# National Committee on Uniform Traffic Control Devices

## National Committee on Uniform Traffic Control Devices (NCUTCD) Recommended Changes to Proposed Text for 11<sup>th</sup> Edition of the MUTCD Docket Number: FHWA-2020-0001

7 **NPA MUTCD Section Number:** Ch 7C

**Figure 7C-1. Two-Lane Pavement Marking of "SCHOOL"**

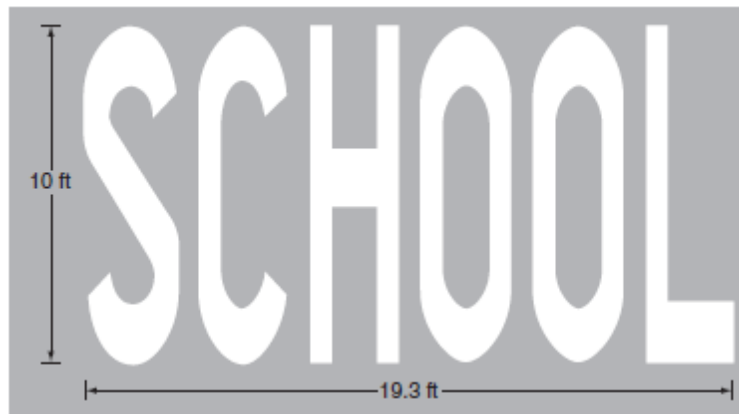
68 **NCUTCD agrees with Figure 7C-1 as presented in the NPA.**
